SUMMARY STATEMENT OF ALEXANDRA BADENHOP (GROUNDWATER)

17TH DECEMBER, 2021

1. This summary statement reflects only the points that differ from those stated in previous evidence and joint witness statements or that require particular emphasis, and are focussed on review of the draft conditions circulated by the Applicant on 15th December.

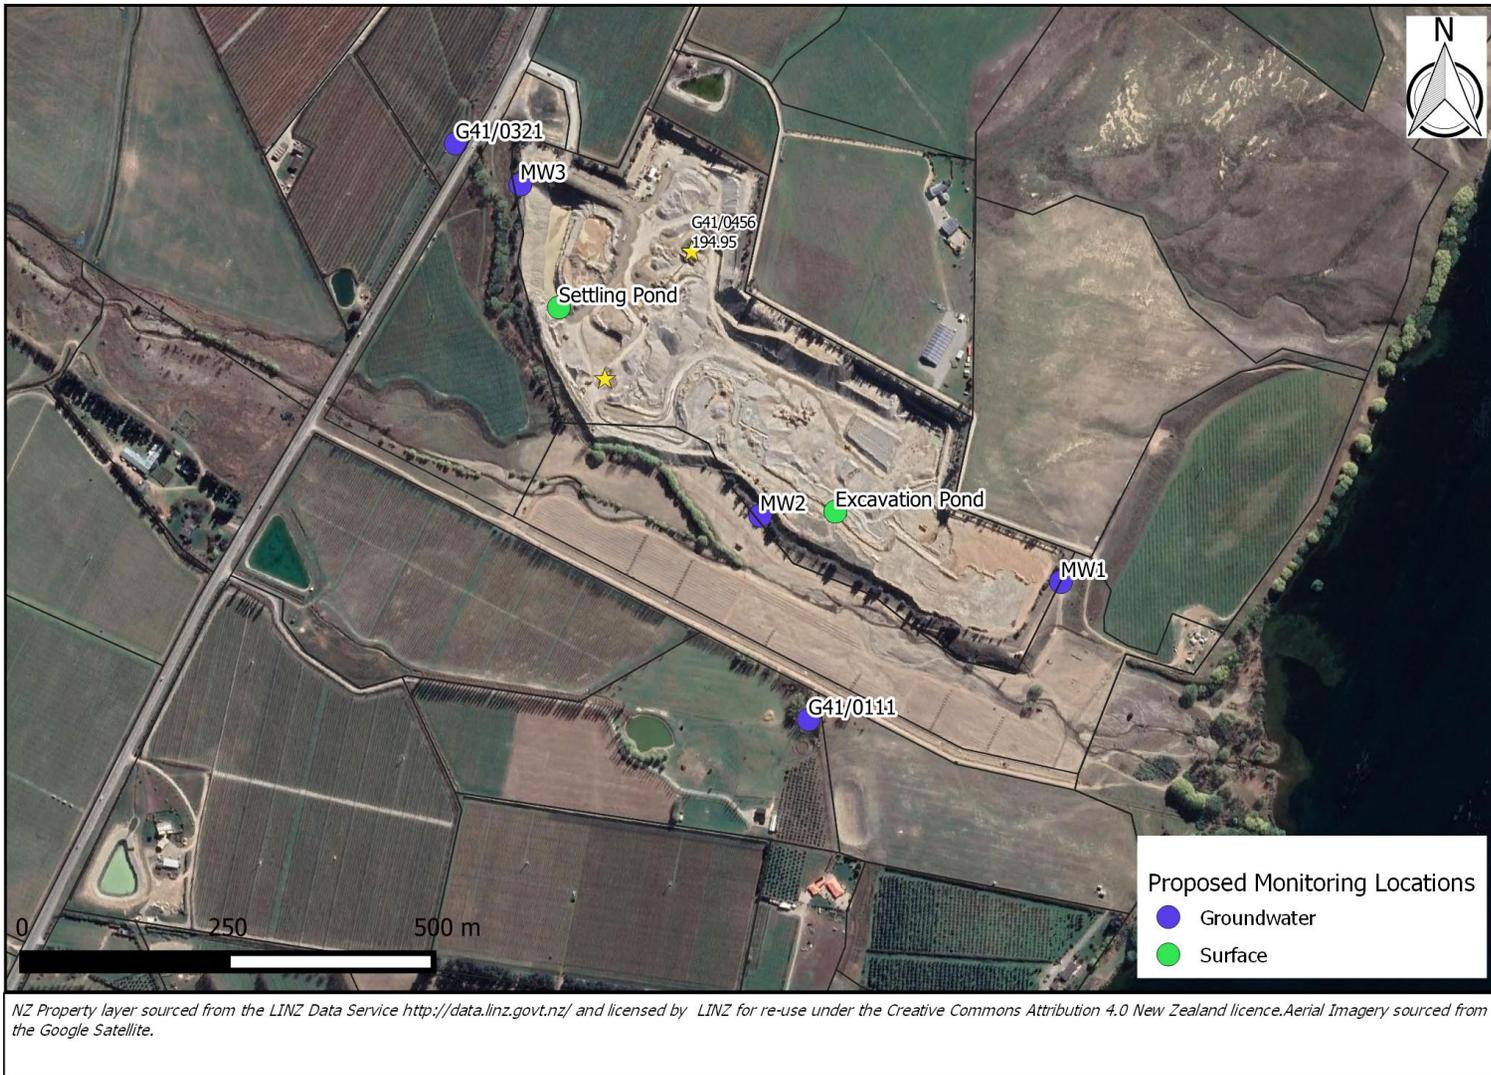
5. New groundwater monitoring locations should consist of dedicated sets of nested piezometers with one screened across the water table and one at 10 m below the water table in each set. Samples should also be taken from:

- a. the settling pond and the exposed area of groundwater (to assess discharge water quality).
 - b. sensitive bores (G41/0321 and G41/0111), and
 - c. G41/0319 to represent an upgradient (control) bore.

- i. Proposed monitoring locations are provided as Figure 1. I recognise that the exact locations of monitoring bores will be constrained by drill rig access and agreement from bore owners, and therefore final locations will need to be confirmed.

- ii. G41/0456 is not recommended as a monitoring bore due to deeper screen depth.
 - iii. Specifications for new monitoring bores should be relative to the groundwater table, not the land surface.
